Design Statement

Yew Tree Cottage
49a Conisboro Avenue

This application is essentially seeking modification of detail given in the recently approved application reference 210156.

Garage Plan:

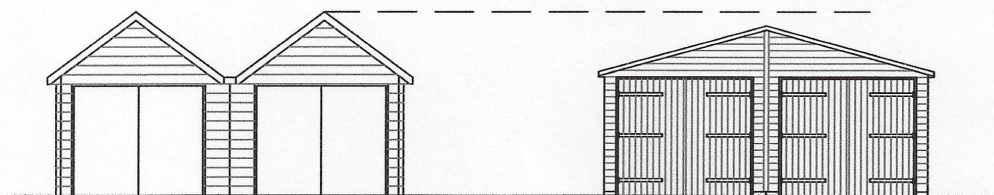
The revised proposal is smaller on plan now being 5.5 x 5.5m rather than the previously approved 5.8m x 5.8m.

Also, the proposed roof shape is different, now being a single pitch. The overall height at ridge line is slightly lower than the approved 210156 scheme.

The shed will remain constructed in a traditional cabin style, now with good quality shiplap boarding which will be dark-stained in the way of a traditional outbuilding. The roof will be finished in a roof-tile-effect Onduline product, red-brown in colour and will not be out of keeping.

The revised version
is smaller all round

The revised version is
simpler and lower

Ground Floor Plan Proposals

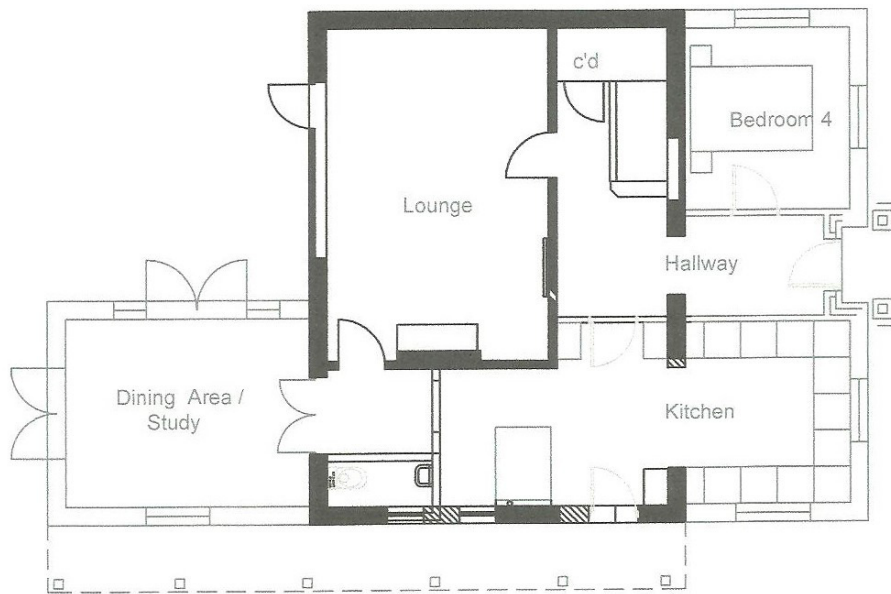
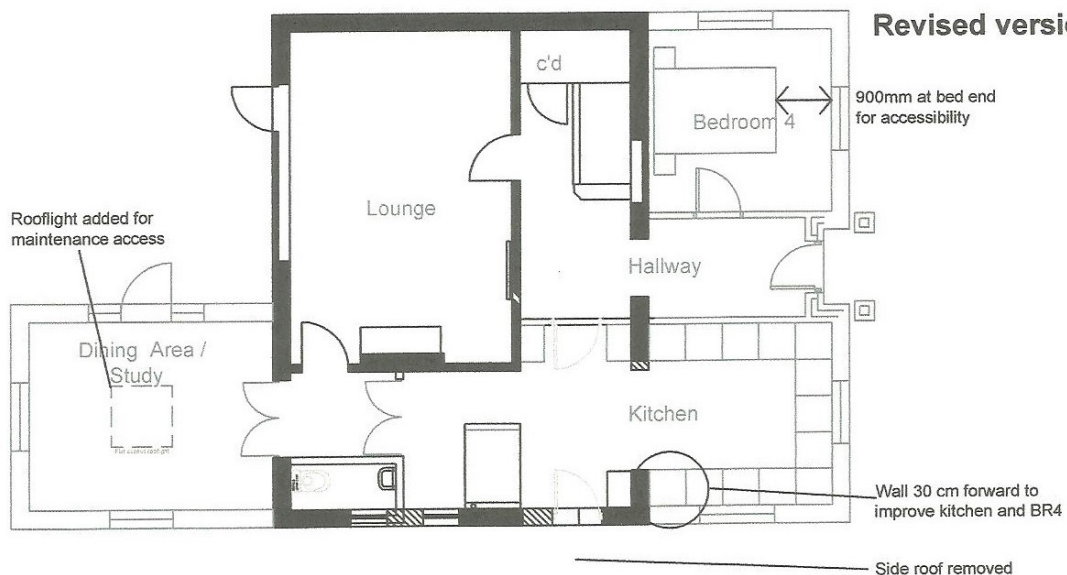
The revised proposal to extend the house at the front and East side is 30 cm further forward from the existing house than the approved scheme.

But this small dimensional revision, subtly improves the proposed kitchen layout and enables full width units to be accommodated all around as the following diagram indicates.

On reflection, the small dimensional change will give space for a wheelchair to move around the bed more freely if need be for example; the space at the end of the bed is now proposed to be 90cm rather than 60cm in the approved plan.

The new BR4 would now be 2.98m x 3.0m in the revised scheme - certainly not excessively large.
